January 3, 2020

Reference: Response to Peer Review Comments
Site Plan Review Application – Camp Pembroke Yurt Village
306 Oldham Street
Pembroke, Massachusetts
B+T Project No. 1762.11

A001

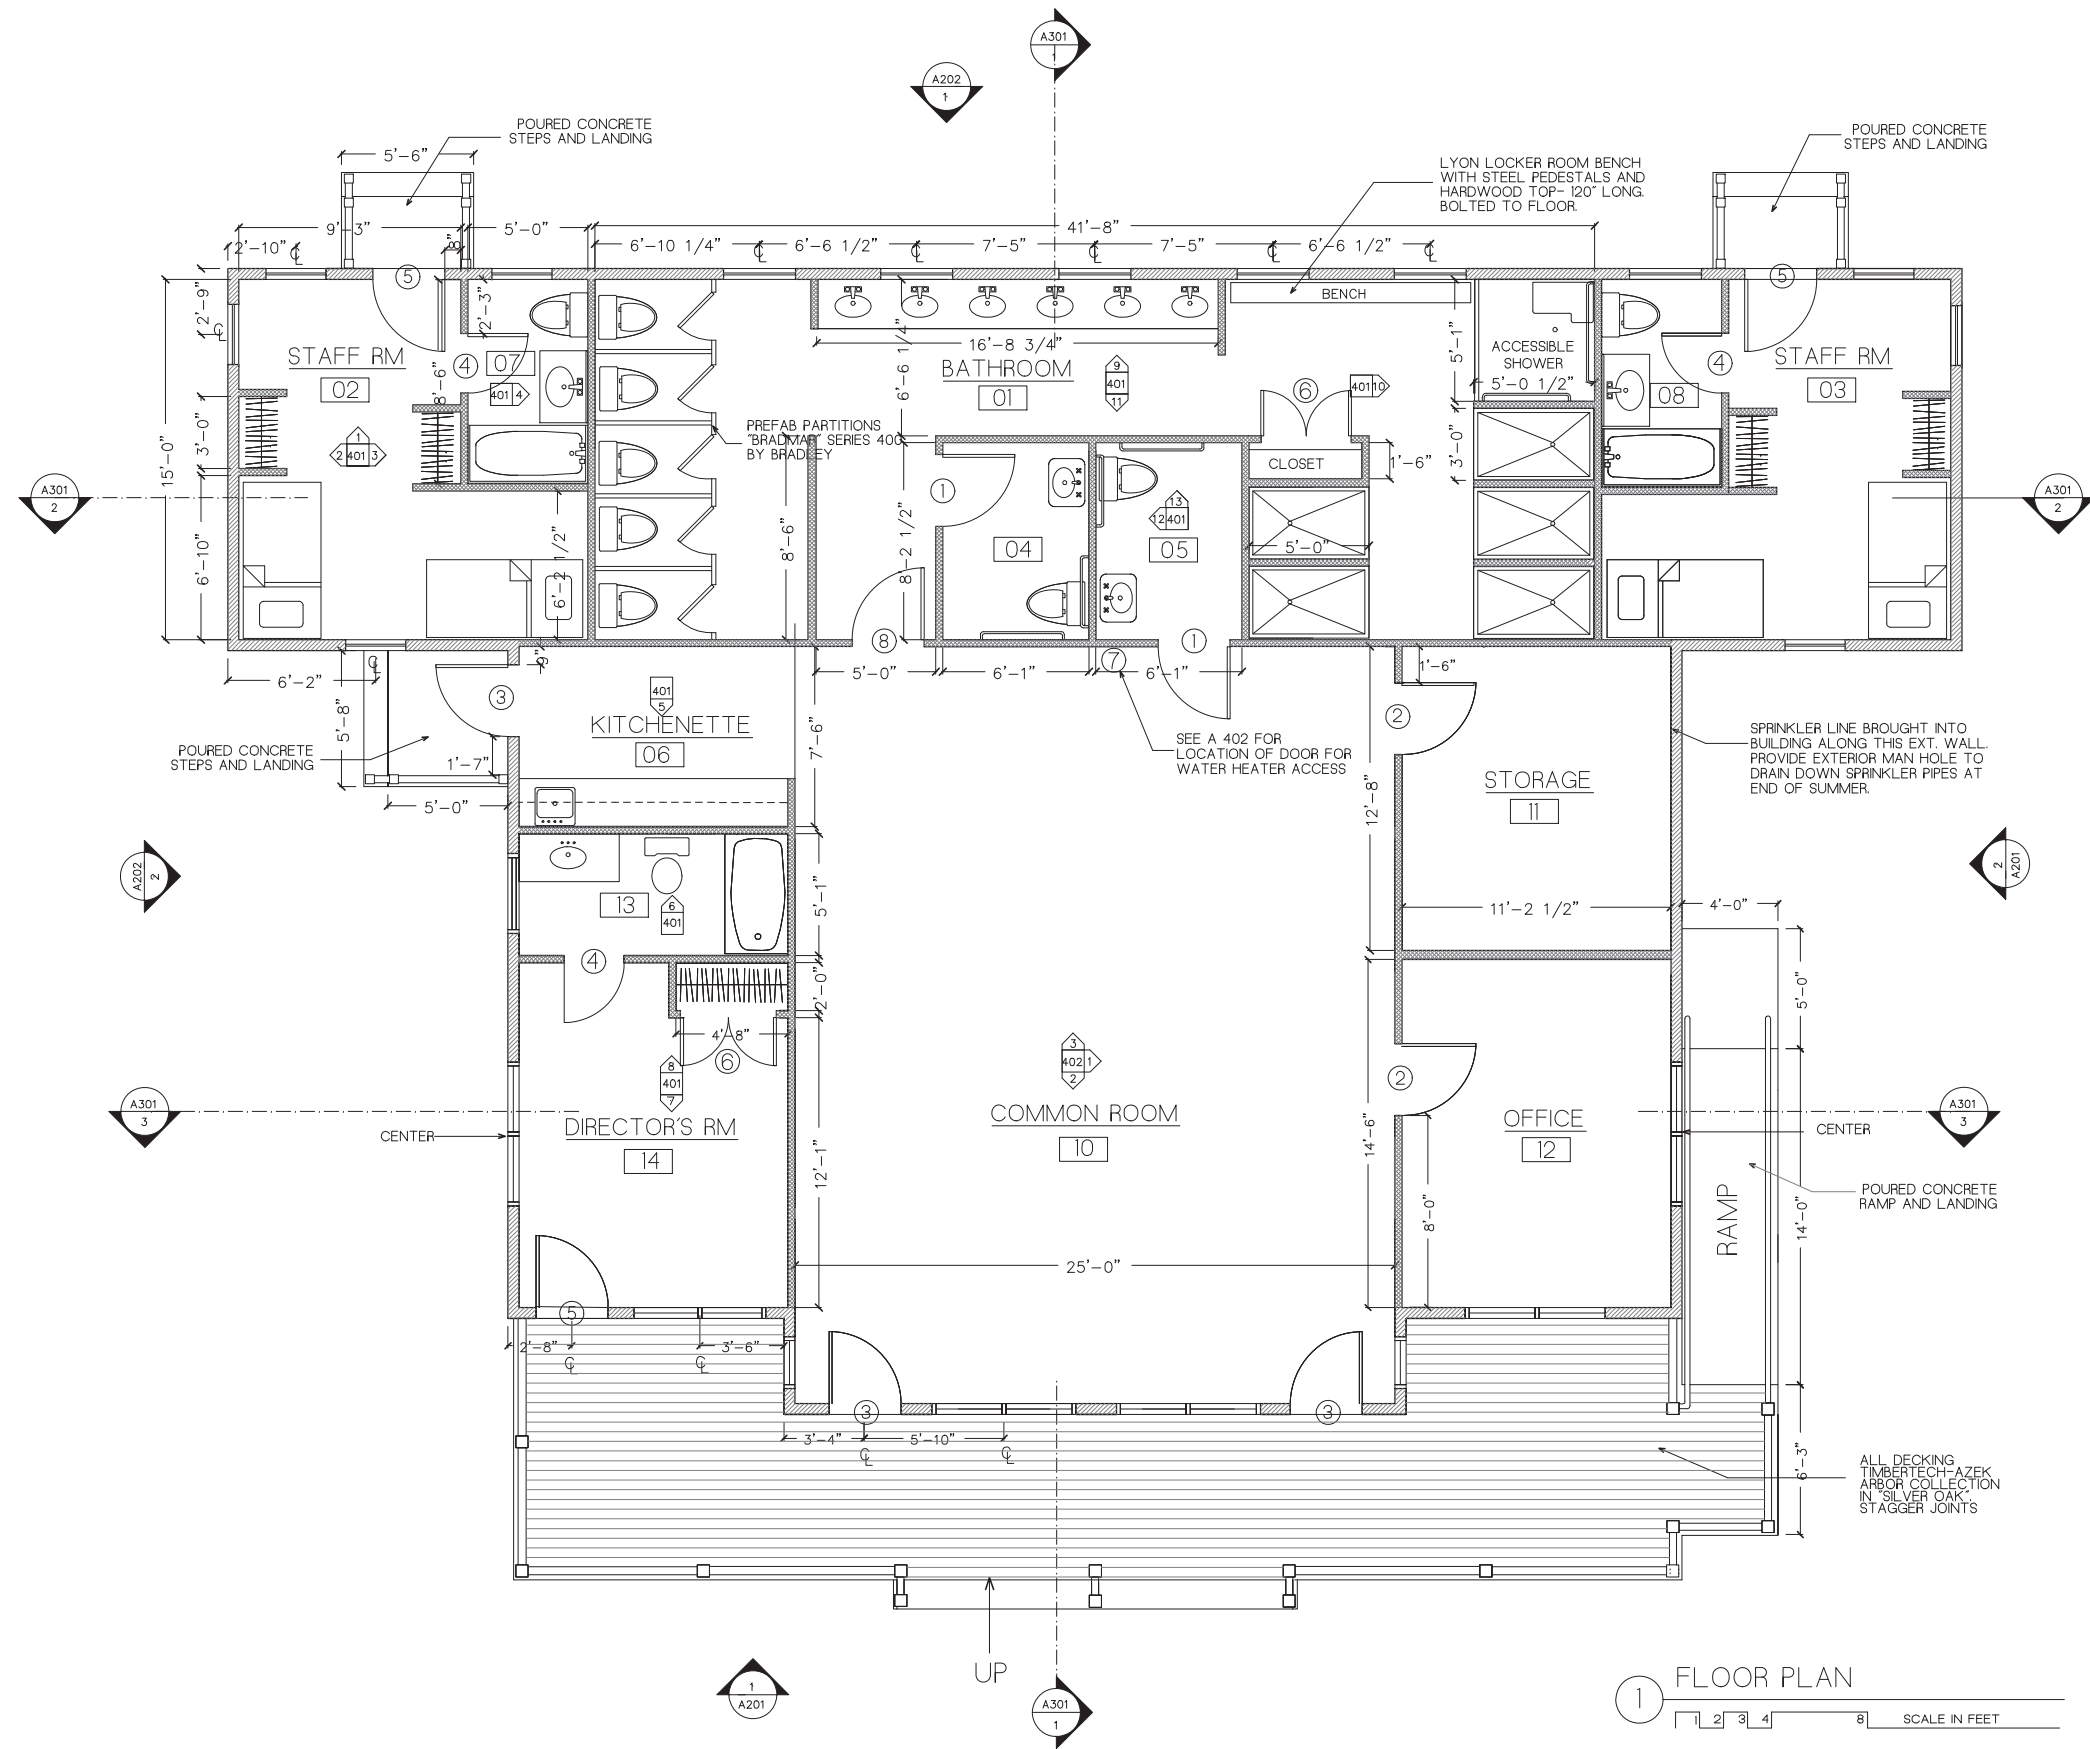
- 4.10 *The elevation and façade treatment of the proposed structures has been provided; however, no floor plans have been submitted. The building materials and colors have not been submitted as required.*

B+T Response: The complete set of architectural plans in reduced-size format is enclosed herewith. The siding will be vinyl and colors will be white with green trim to match other buildings on-site.
